BOARD ACTION REPORT – APPEALABLE ITEM

Project Name:	701 N Swinton Avenue
Project Location:	701 N Swinton Avenue
Request:	Certificate of Appropriateness (COA)
Board:	Historic Preservation Board
Meeting Date:	May 1, 2019

STAFF REPORT

ITEM: 701 N Swinton Avenue, Del Ida Park Historic District– a Certificate of Appropriateness (2019-116) associated with a 462 square foot addition to the existing contributing single-family residence.

PROPOSED RIGHT (SOUTH) ELEVATION 1/4" Sc.

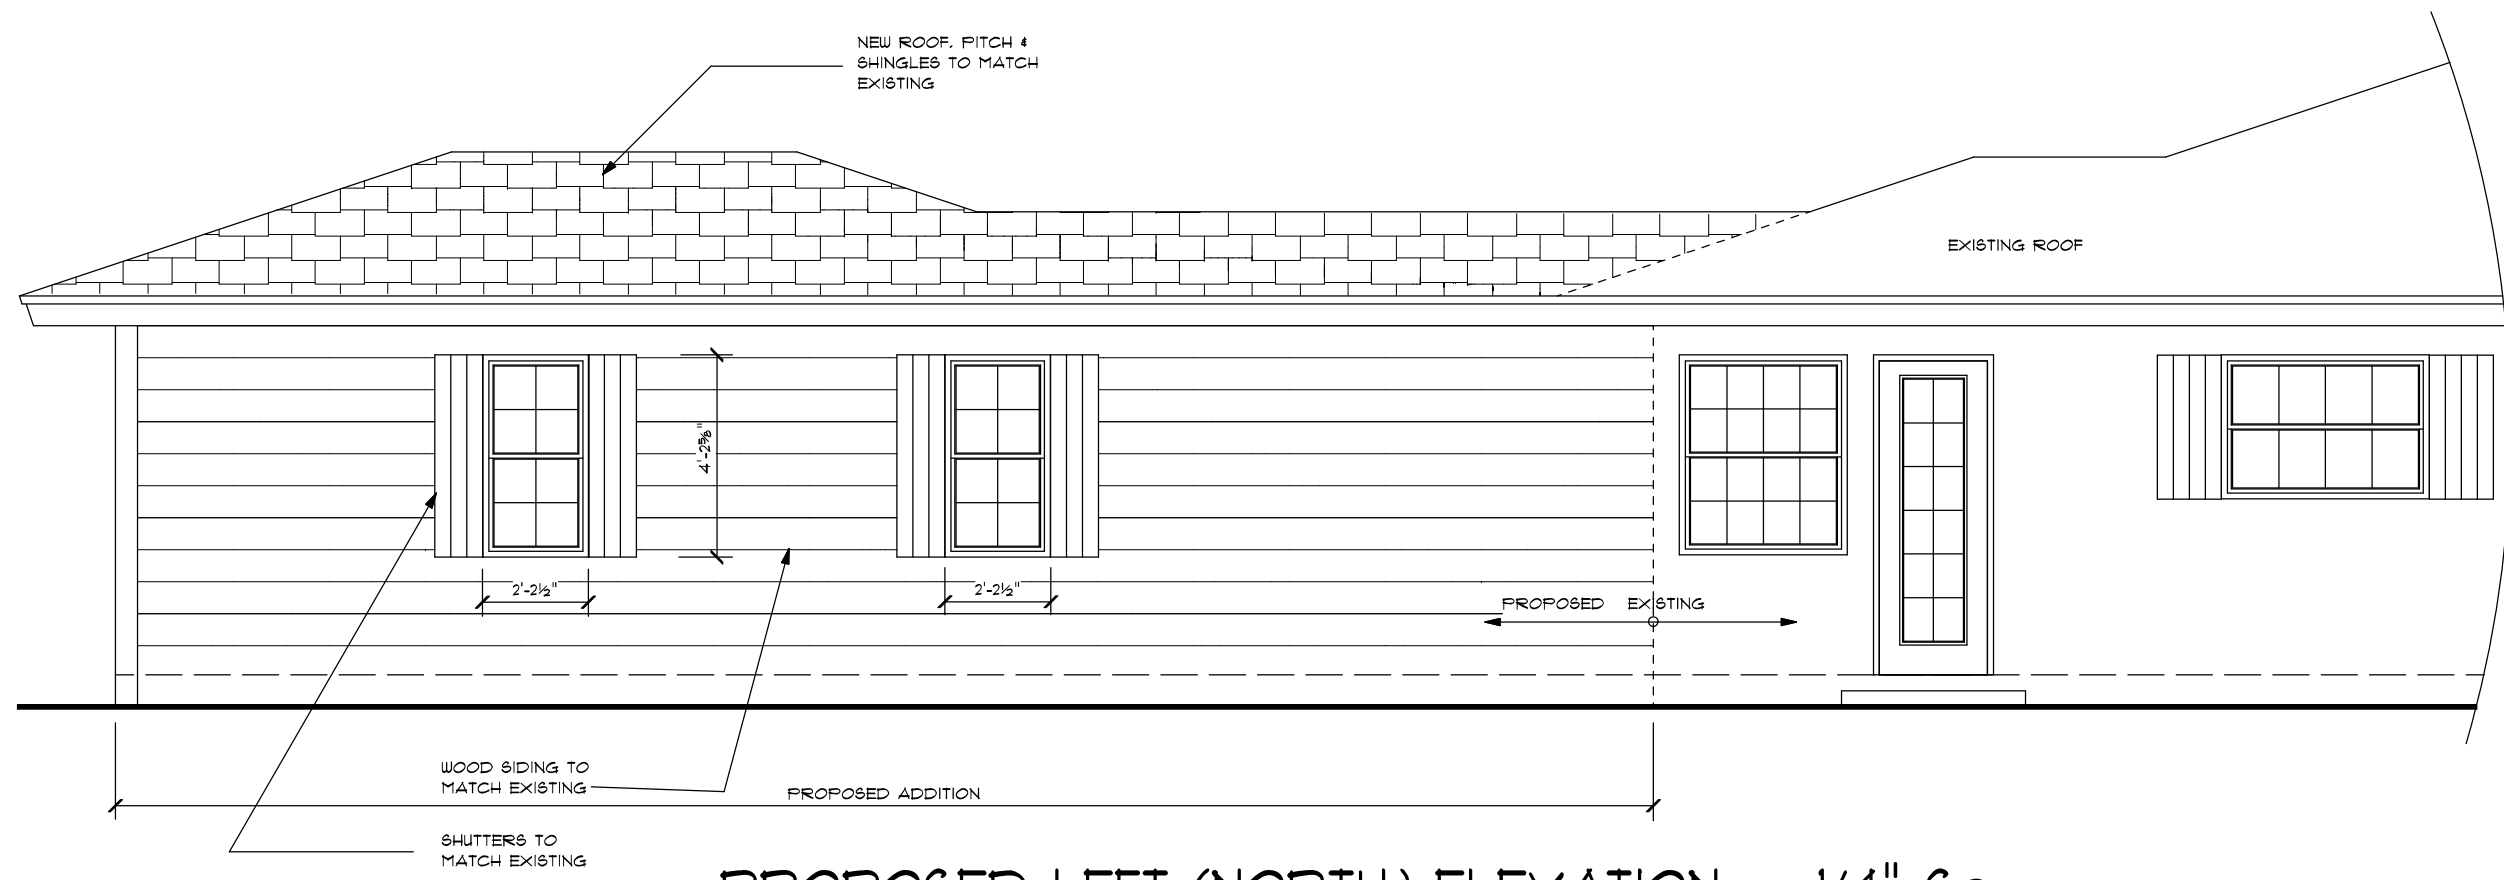
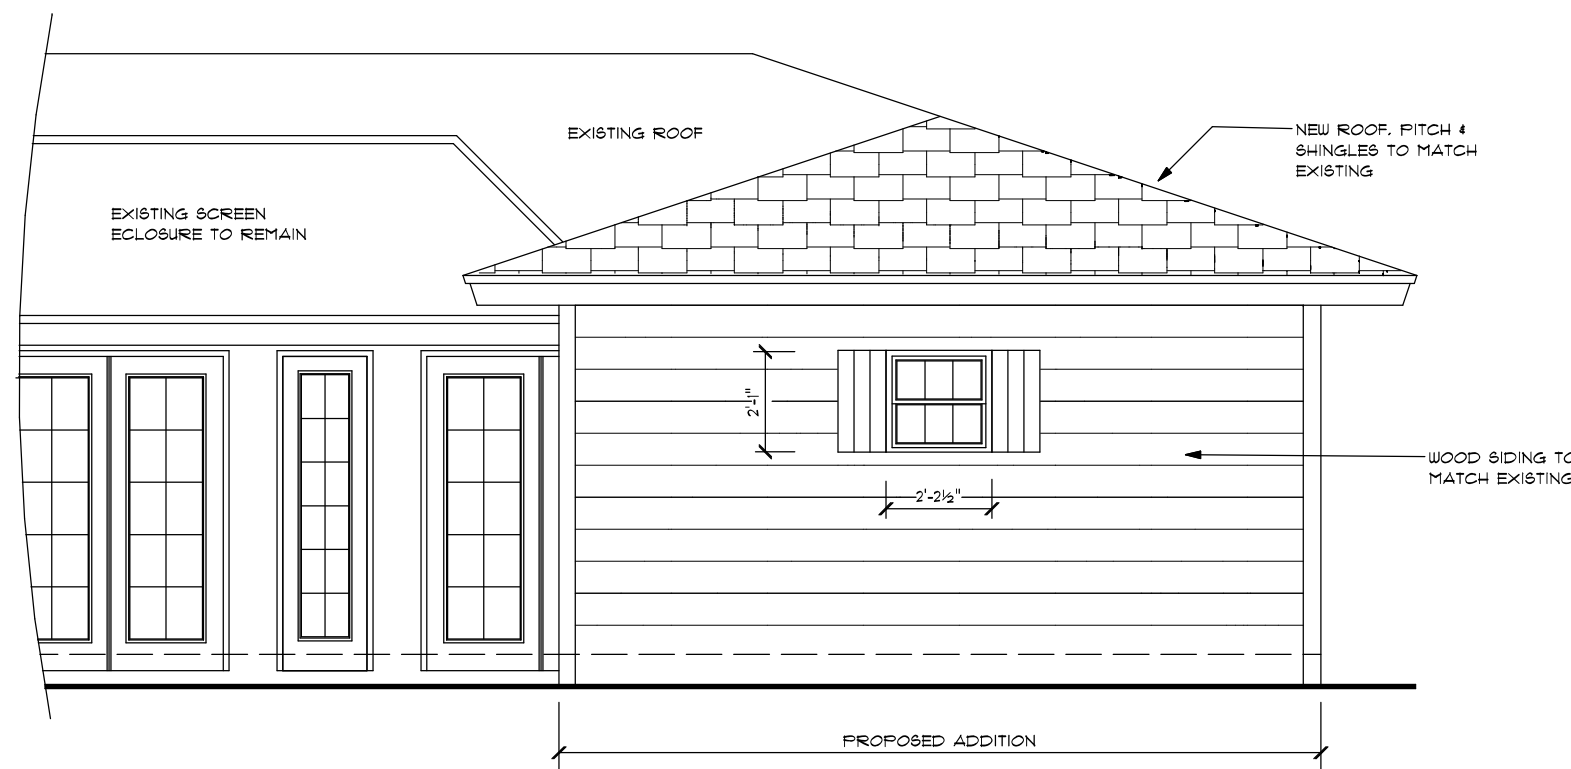
The proposal includes an addition to the east side of the property for the single-family structure to include a bedroom, bathroom, and closet space. Proposed windows will be clear, impact resistant glass and doors materials will be aluminum with white frames, also will the same clear, impact resistant glass. The proposed windows are slightly different than the existing in size, however have a similar muntin pattern as the existing providing for a slight differentiation of old to new.

The proposed addition's height at 13'2 3/4" does not exceed the height of the existing structure at 15'-3 1/2". The materials for addition will be the same as existing including cedar siding, wood shutters and asphalt roof shingles will match the existing structure. The paint color for the exterior walls will match the existing "Celery Ice" by Behr, the window shutters will be "Blue Square" by Behr, with white trim for the windows and doors. Colors are compatible as they are the same as existing structure. It is noted that the purple trim detail around the top of the existing structure shall be painted "Blue Square" as was previously approved. This item is attached as a condition of approval.

The proposed 1-story addition to is visually compatible and in direct relationship with the low-scale of the existing structure. The addition is located behind the existing structure to the northeast. The addition is not placed forward of the plane of existing structure, such design protects the historic integrity of the historic district and surrounding area.

1. That the purple trim detail around the top of the existing structure shall be painted "Blue Square"
